1 [Changing Official Sidewalk Width - Portions of Golden Gate Avenue, Polk Street, and  
2 Redwood Alley]

**DPW Order No: 179,914**  
**CITY AND COUNTY OF SAN FRANCISCO**  
**DEPARTMENT OF PUBLIC WORKS**

OFFICIAL SIDEWALK CHANGE  
ON BLOCK 0766

**Case No.:** Case No. 2011.0742R  
Major Encroachment Permit for Sidewalk Bulbouts on Golden Gate Avenue, Polk Street and Redwood Street associated with PUC Office Building

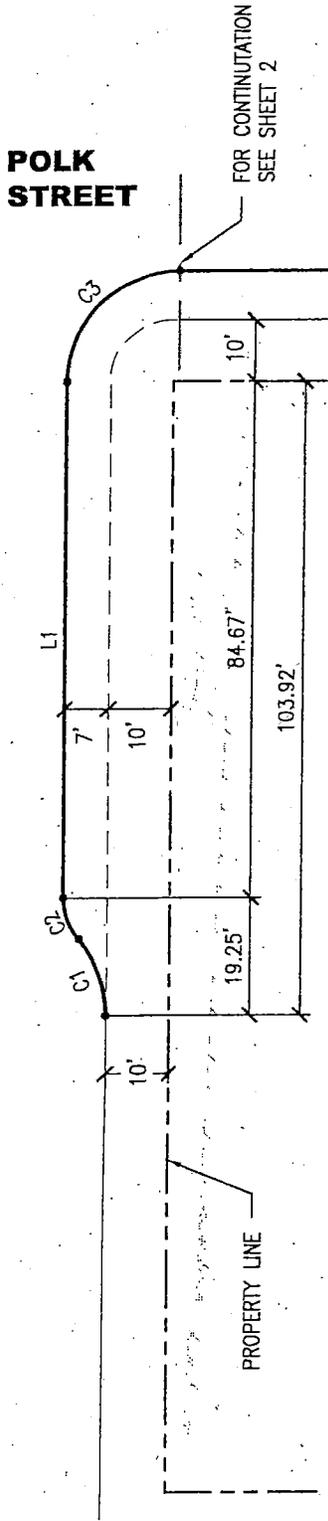
9 Section 1593. Changing the official sidewalk width of: a) Golden Gate Avenue starting at the  
10 southwest corner of the intersection of Golden Gate Avenue and Polk Street and continuing west for  
11 104 feet, b) Polk Street starting at the southwest corner of the intersection of Golden Gate Avenue and  
12 Polk Street and continuing south 78 feet, and c) Redwood Alley starting at the northwest corner of the  
13 intersection of Polk Street and Redwood Alley and continuing west 173 feet, as shown on Department  
14 of Public Works drawing O-20-702, of which is in the Clerk of the Board of Supervisors File No.  
15 120138.

TRANSMITTING TO THE BOARD OF SUPERVISORS LEGISLATION CHANGING THE OFFICIAL SIDEWALK WIDTHS OF GOLDEN GATE AVENUE STARTING AT THE SOUTHWEST CORNER OF THE INTERSECTION OF GOLDEN GATE AVENUE AND POLK STREET AND CONTINUING WEST 104 FEET, POLK STREET STARTING AT THE SOUTHWEST CORNER OF THE INTERSECTION OF GOLDEN GATE AVENUE AND POLK STREET AND CONTINUING SOUTH FOR 78 FEET, AND REDWOOD ALLEY STARTING AT THE NORTHWEST CORNER OF THE INTERSECTION OF POLK STREET AND REDWOOD ALLEY AND CONTINUING WEST FOR 173 FEET; AS SHOWN ON DEPARTMENT OF PUBLIC WORKS DRAWING Q-20-702.
